## BALLARD YARDS

SDCI #3030168

## DESIGN RECOMMENDATION

JANUARY 14, 2019

## 2 INTERIOR FACADES

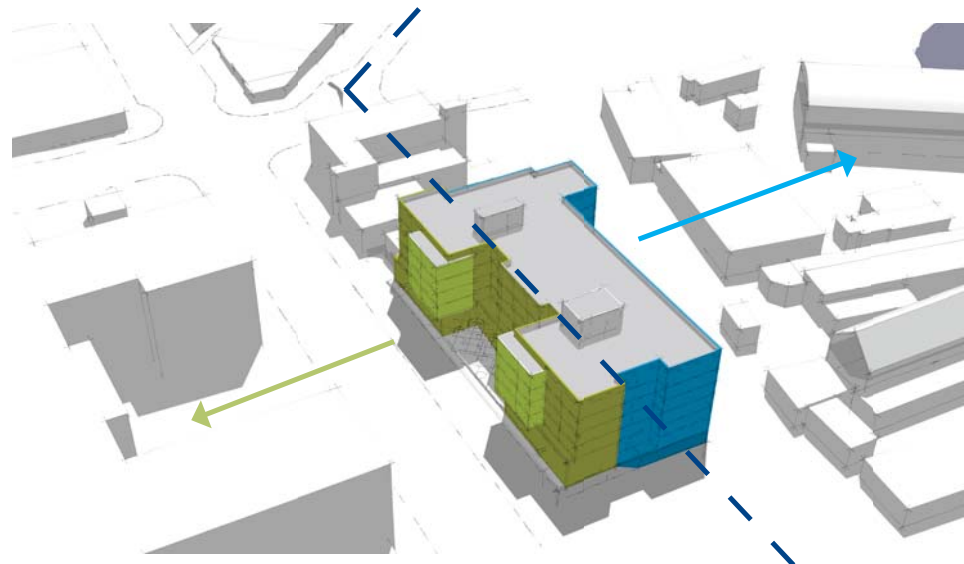
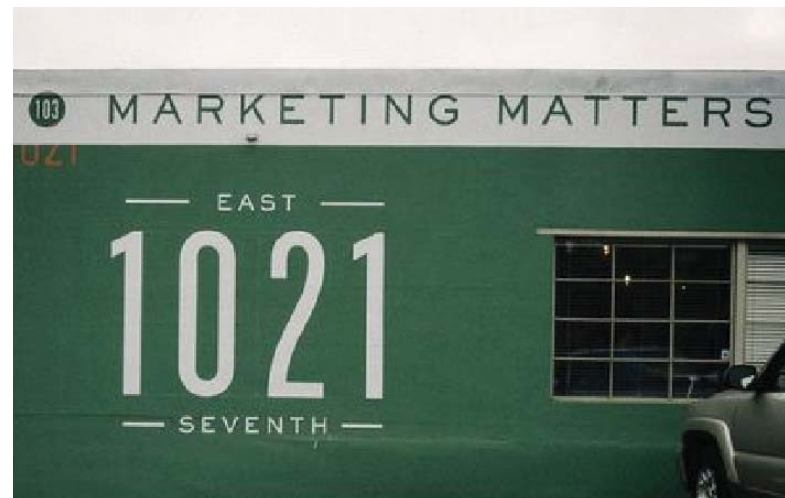
a. The Board supported the intent indicated in the meeting materials but/and made clear that though they were on interior lot-lines, these were important elevations. (CS3, DC2)

b. The Board noted particular interest in the east elevation (and southeast corner), as they likely will remain visible for quite some time. (CS3, DC2)

This building is designed as a four sided building, with attention paid to all facades. A substantial portion of the east and west facades are set back from the property line to allow light and air into the units. The façade detailing here is an extension of the language of the south façade, which unifies the building massing around the corners. The portions of the façade located directly on the property line are an extension of the material language along Market Street, again unifying the massing around the corners.

The portions of these facades that are located directly on the property line are seen as opportunities for art and/or graphic signage. The team is looking to hire an artist to create a work that is in keeping with the industrial and historical signage already found in the area. Image examples are provided on the adjacent page.

The southeast corner of the building is highly visible as Shilshole Ave swings north towards Market Street. The design includes a mass on the corner that relates to and acts as a third "lantern" element, giving prominence and adding visual interest to the streetscape.

5 RETAIL EDGES

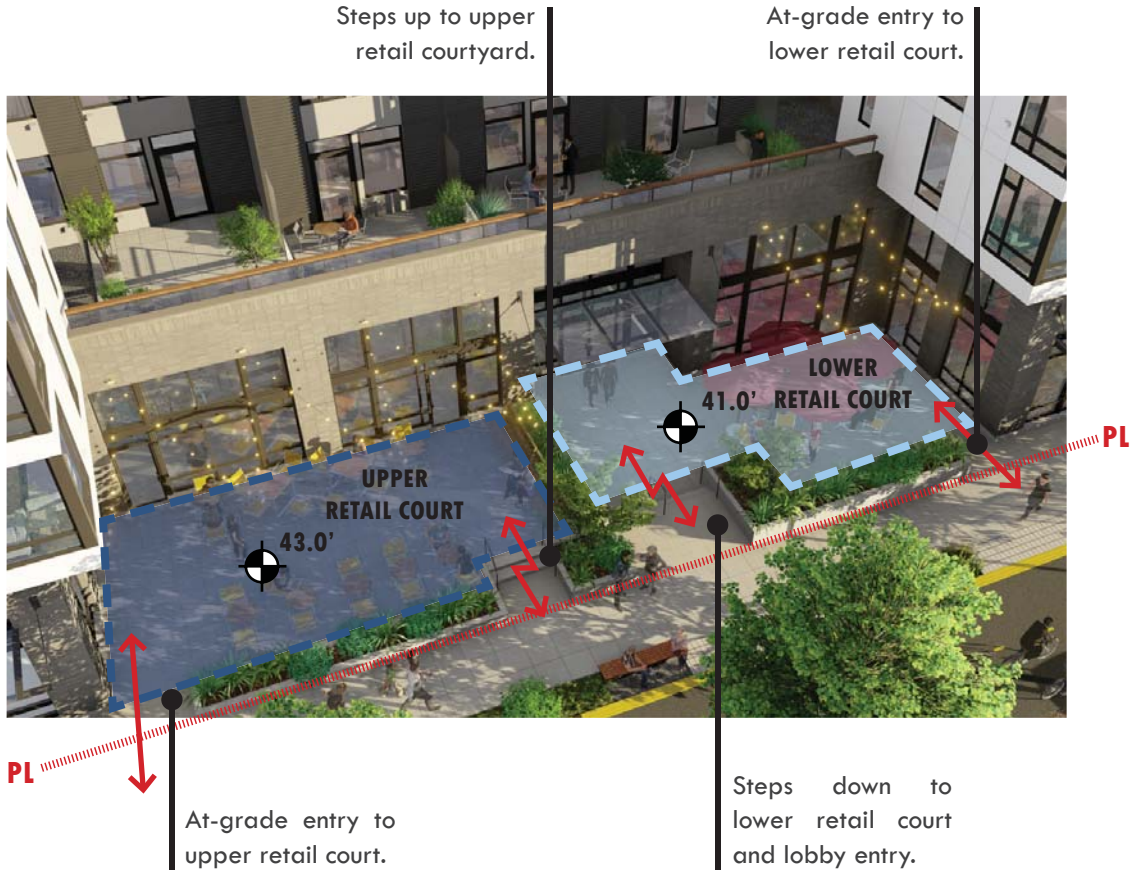
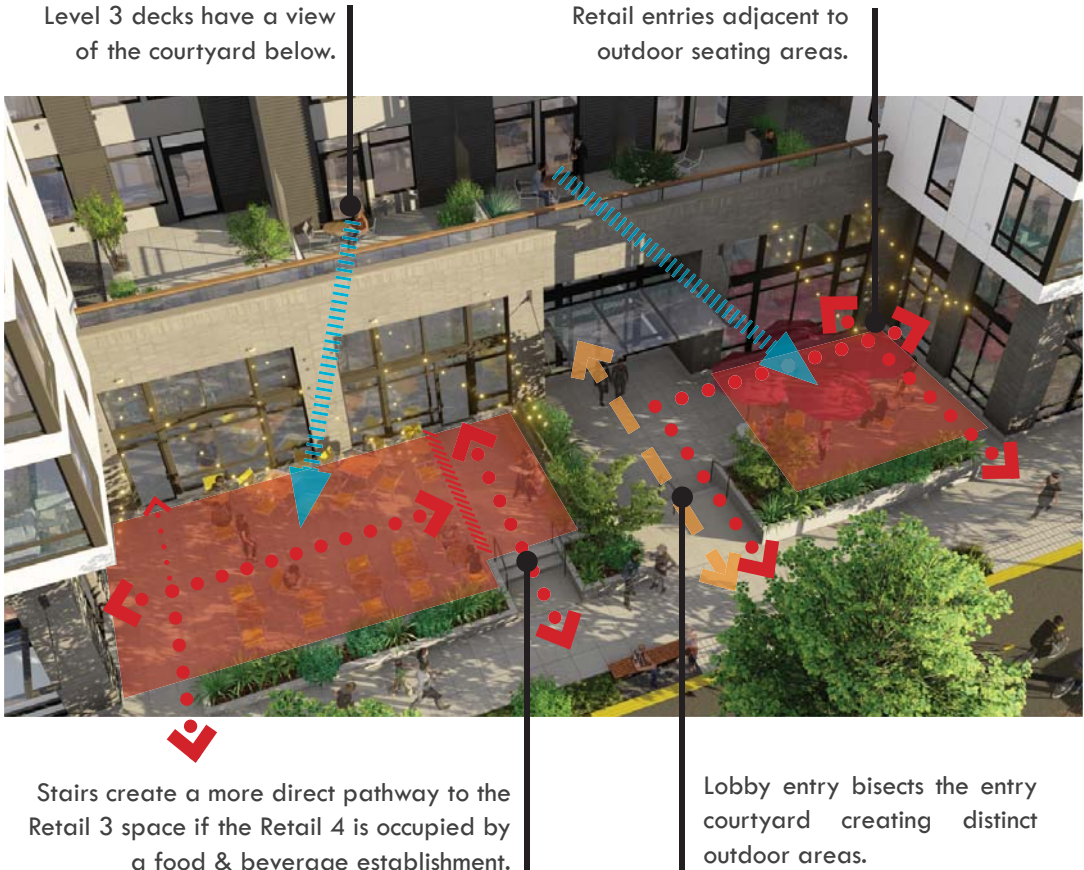
The Board supported the well-articulated retail base of the preferred scheme and the stepping of the floor plates with grade. (DC2-D, PL3-C, CS3-A) (PL2-II-ii)

The Board expressed support for this element and asked that the retail spaces and supporting amenities (including balconies) be designed to activate this area.

The building design has followed the preferred option 3 massing and stepped floor plates for the retail and corresponding courtyard.

The building design has maintained the courtyard and continued to request this feature as a departure. The retail spaces surround the courtyard and have entrances from the courtyard to encourage the businesses to take advantage of this space.

To further activate this space, patios have been added to Level 3 facing towards the courtyard for private residential use.

4) MATERIALS

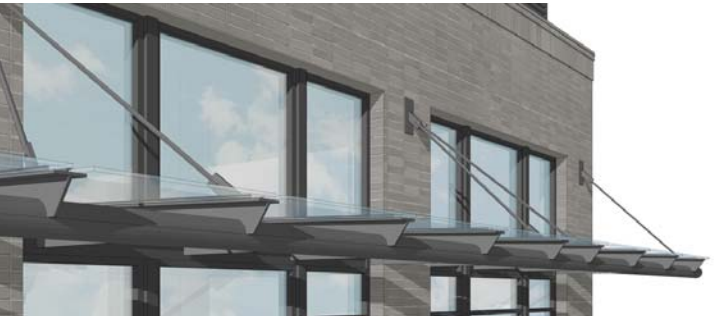
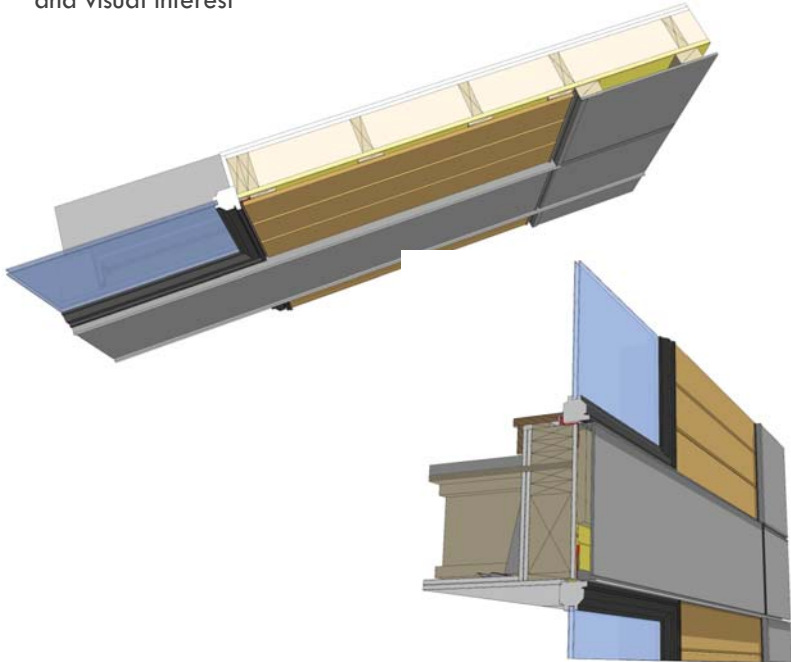
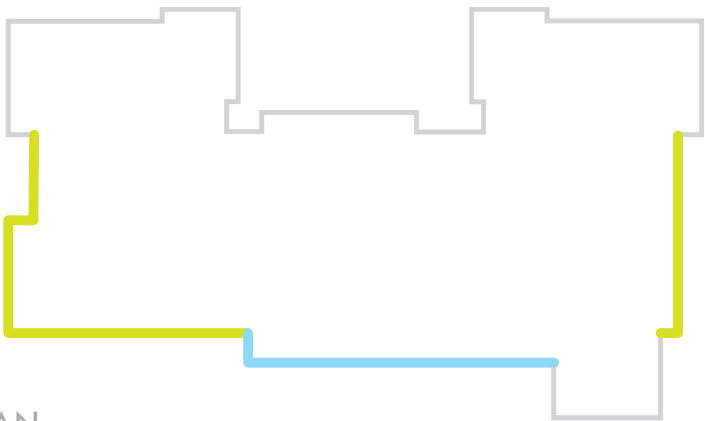
a. The Board supported the choice of masonry as the principal cladding material, and the limited palette of exterior materials. (DC2-C, DC4-A)b. The Board noted particular interest in the east elevation (and southeast corner), as they likely will remain visible for quite some time. (CS3, DC2)

b. The Board agreed that all of the materials should be high quality and well detailed, and that all material changes follow a consistent logic in their application. (DC2-C, DC4-A)( DC4-I-I, CS3-I-iv)

Upon issuance of the EDG minutes, VIA noted to SDCI that masonry was presented along Market Street for the retail level. This is far from the principle cladding material of the building. The 2-stories of masonry along the pedestrian oriented frontage of Market Street has been maintained in the project.

The façade will consist of 4 pattern languages, one of which is the lanterns as described on pages 14 and 15. The 4 pattern languages correspond directly to the massing and the duality of the location between Market Street and a working waterfront.

The dominant language along Market Street reflects the more historic masonry buildings in its horizontality, order, and the proportions of the punched windows. The language of the lanterns serves as a compliment to the order and regularity of the dominant expression.

The dominant language along 54th Street responds to the working waterfront with simpler expression, larger scale, and rhythm in detailing. The detailing around the windows, at the corners and edges, and at reveal lines is treated with careful attention. These elements highlight alignments, enhance verticality or horizontality, and create shadow lines for visual interest. The accent language maintains the simple order while breaking up the long façade with an additional massing/expression.

3) LANTERN ELEMENTS

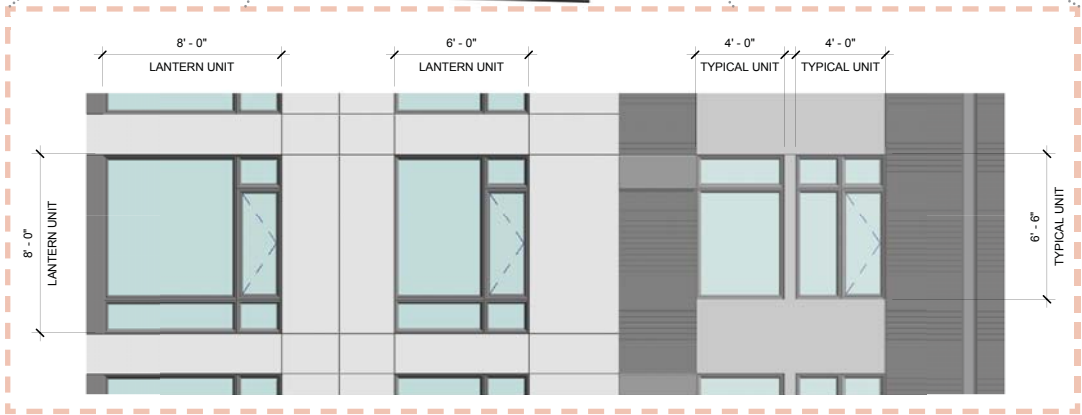
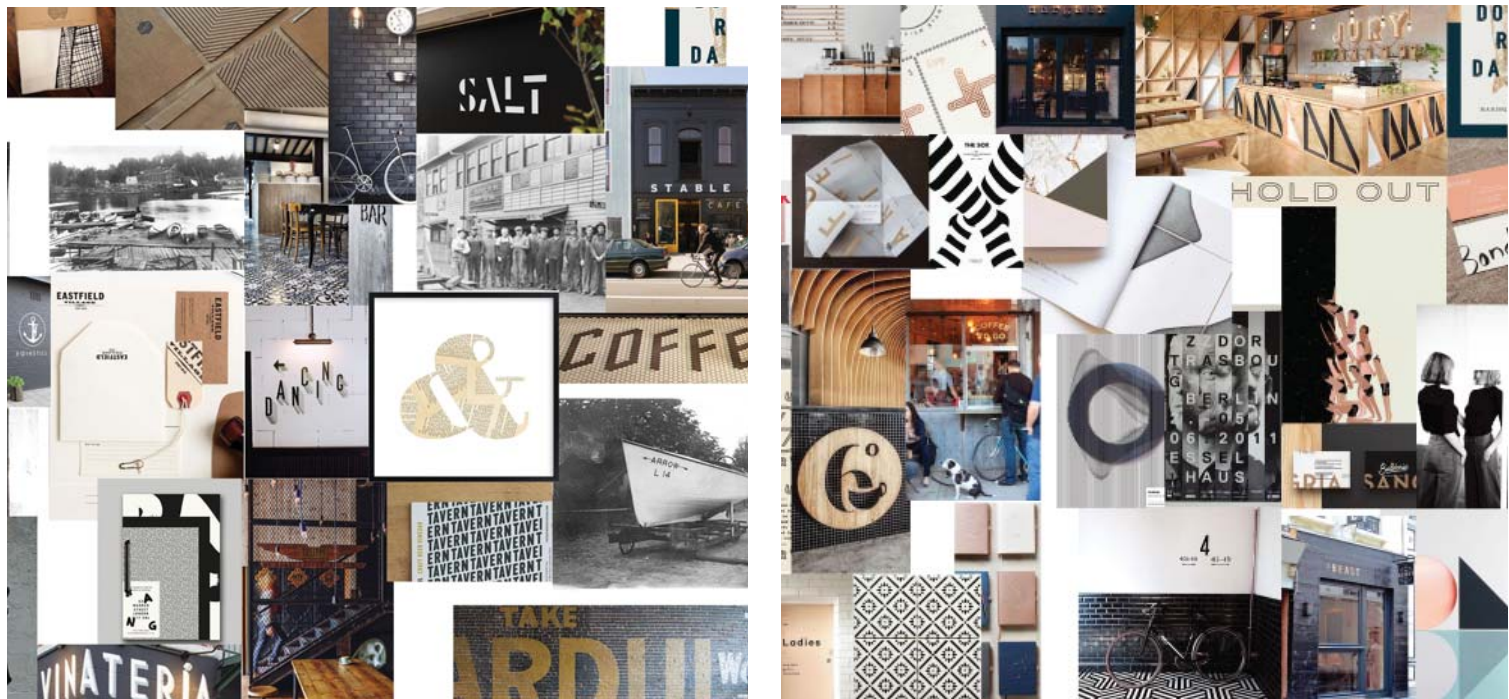
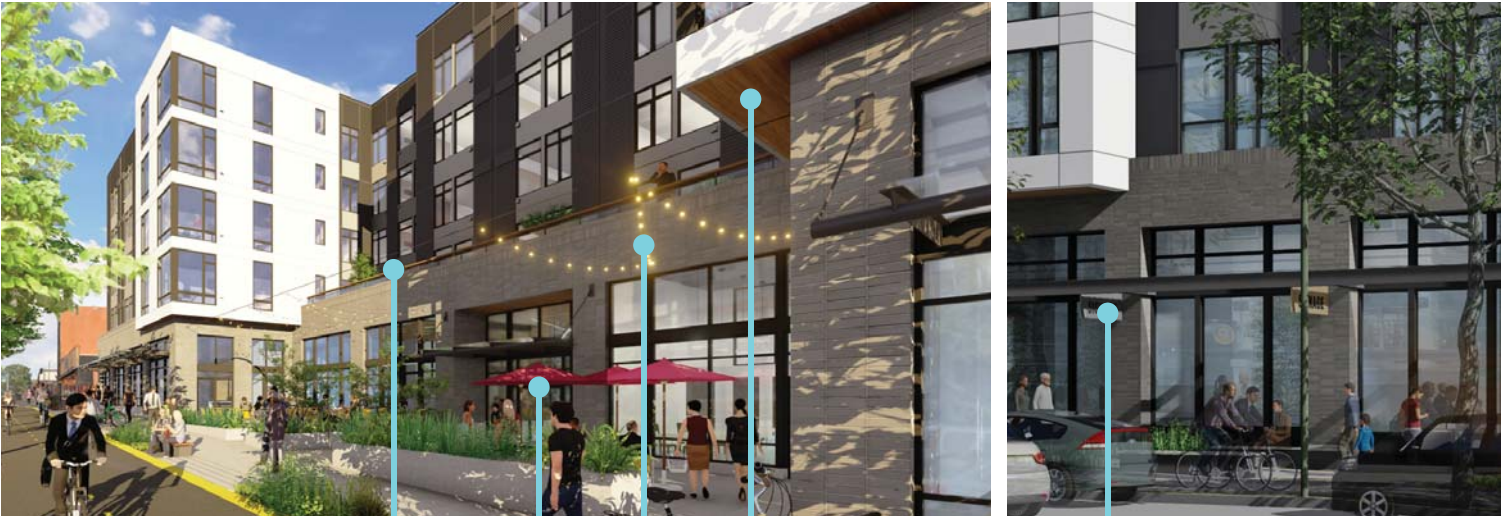
- a. The Board had a wide-ranging discussion of these elements; their function, expression, composition, and merit for departures. The conversation ended in the agreement that their potential as compositional elements outweighed the reservations some Board members had about their current expression.
- b. The Board indicated an openness to the associated departure (#2) and asked for a rigorous exploration of alternatives, including:
  - i. Asymmetry, in the lanterns and in the entire composition
  - ii. Lantern-bays that do not extend full height.
  - iii. Significant glazing relative to the rest of the building.
  - iv. Exploring contrast with the larger composition; with materials, with detailing, with color. (PL3-C, DC2-B, DC2-C, DC2-E)

Asymmetry is expressed in the proposed solution. Diagram A depicts true symmetry. Diagram B (the proposed design) contains asymmetry within each wing of the building, by pushing the “lantern elements” off center an to the corners of the building wings, bookending and focusing attention on the courtyard.

The design team explored the depth and height of the lantern bays. Any reduction in height detracted from the massing, and gave the impression that bays were an afterthought. The full height bays are better integrated with the main building massing. The depth of the lantern bays were reduced from what was presented in EDG. The departure request is still required, but the requested area of encroachment has been reduced.

The lantern bay windows are floor to ceiling, and larger than the windows in the rest of the building. This provides contrast, and highlights the importance of these feature elements. The material of the lanterns is different in color, pattern, and texture than the remainder of the building, further enhancing the importance of these elements on the façade.
